Title:                   Advisory Committee on Reactor Safeguards  
                              AP 1000 Subcommittee

Date:                    October 18, 2011

In this meeting, the Subcommittee will review -- I'm sure we were ready to go on the corner. I guess we are. In this meeting, the Subcommittee will review Levy Nuclear Plant Units 1 and 2 subsequent combined license application. Previously, we've reviewed a SCOL for an existing site. This will be our first opportunity to do so for a greenfield site.

**Advanced Safety Evaluation Section 2.5  
Geology, Seismology, and Geotechnical Engineering**

Mean hazard curves for the NMSZ and Charleston sources of repeated large-magnitude earthquakes. (AFSER Figure 2.5.2-6)

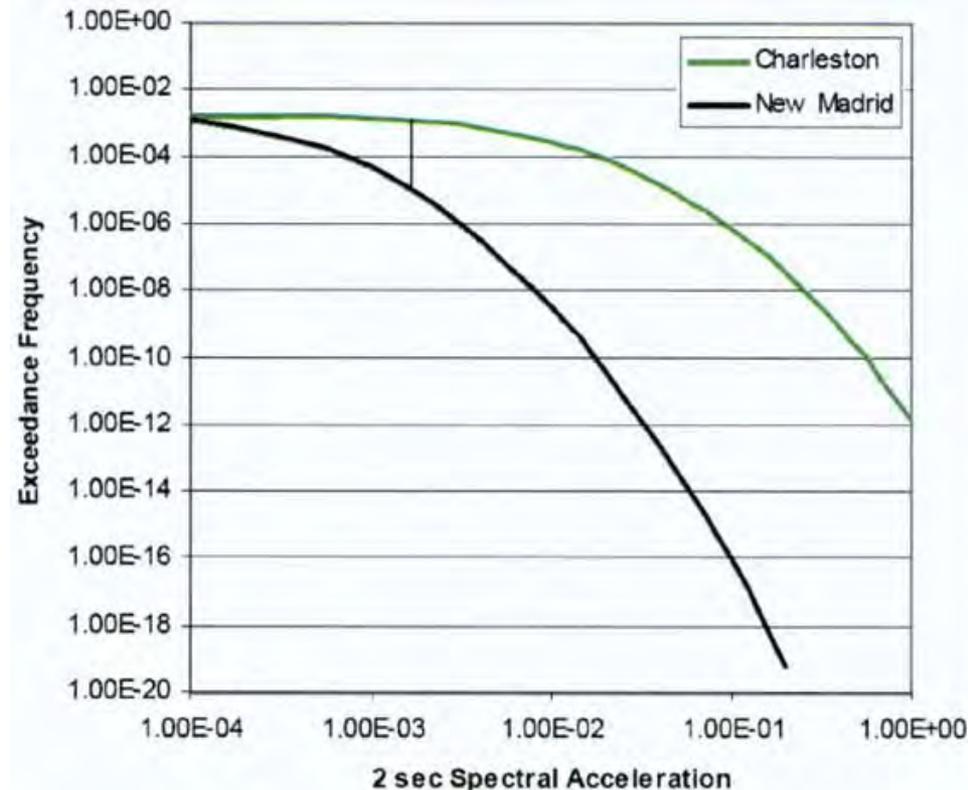
- Issue: The applicant did not discuss the effects of the NMSZ in their FSAR. The staff was concerned about the influence of the NMSZ on the seismic hazard at the LNP site.
- Resolution: The applicant showed that the NMSZ is less than 1 percent of the hazard from the Charleston source at 2-second mean spectral acceleration. Therefore, the effect of the NMSZ on the overall hazard at the LNP site will be less than 1 percent and this issue is resolved.

### Gulf Coast Source Zone (GCSZ)

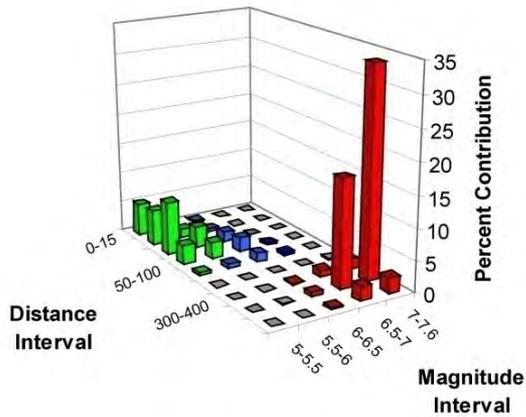
- Issue: The GCSZ is included in EPRI/SOG source modeling. Two earthquakes occurred in the Gulf of Mexico in 2006 with  $m_b$  6.1 and 5.5, exceeding the maximum magnitude distribution estimated by the original EPRI teams. The applicant updated the GCSZ magnitude distributions using a SSHAC Level II study. The SSHAC review panel rejected the TI team's distribution recommendation, but the staff believes the TI's update reflected the technical community consensus.
- Resolution: The applicant implemented a sensitivity test with different magnitude distribution scenarios. The sensitivity test indicates that even using the TI team's recommended distribution, the seismic hazard increase at the LNP site is relatively small (<8%). Therefore, this issue is resolved. The staff is tracking related FSAR changes as **Confirmatory Item 2.5.2-1**.

Pre- and post-grouting seismic wave velocities measurements (AFSER Figure 2.5.2-9) 22

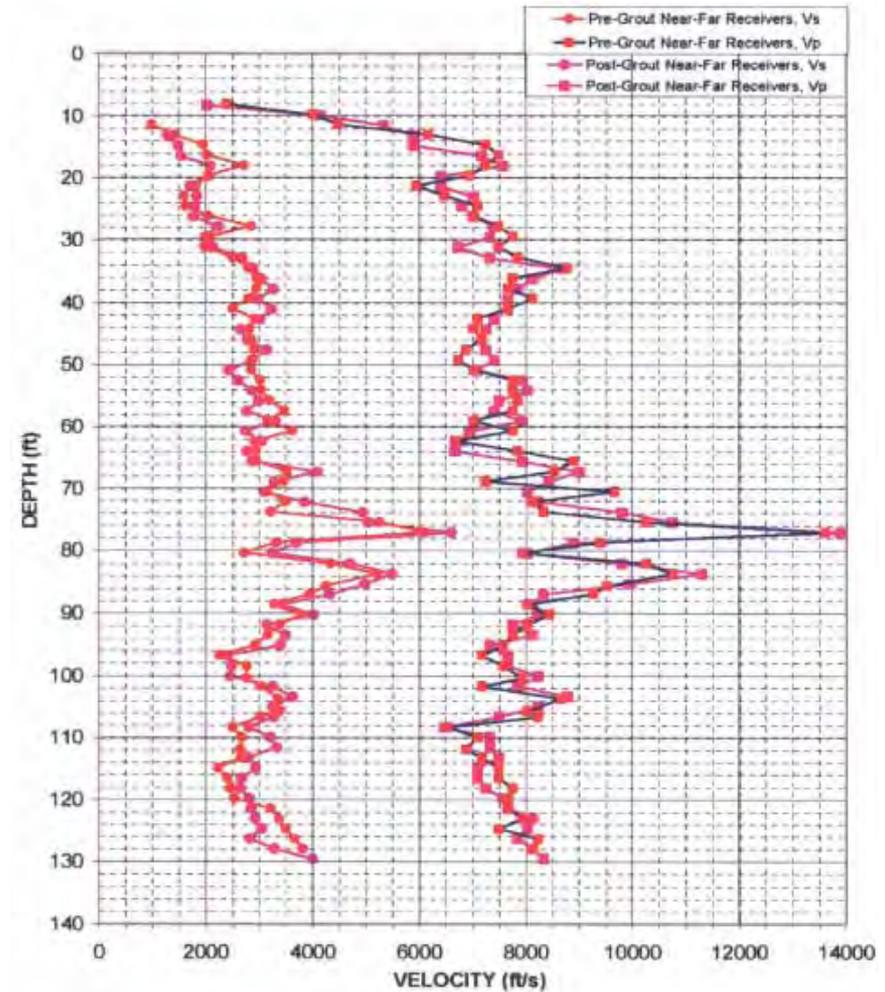
- Issue: Staff was concerned that seismic wave velocities are the same before and after the applicant's grouting program.
- Resolution: Applicant's grout test program measured velocities pre- and post-grouting. The measurements demonstrate that the grouting program do not alter the measurements of seismic wave velocities. Therefore, this issue is resolved.
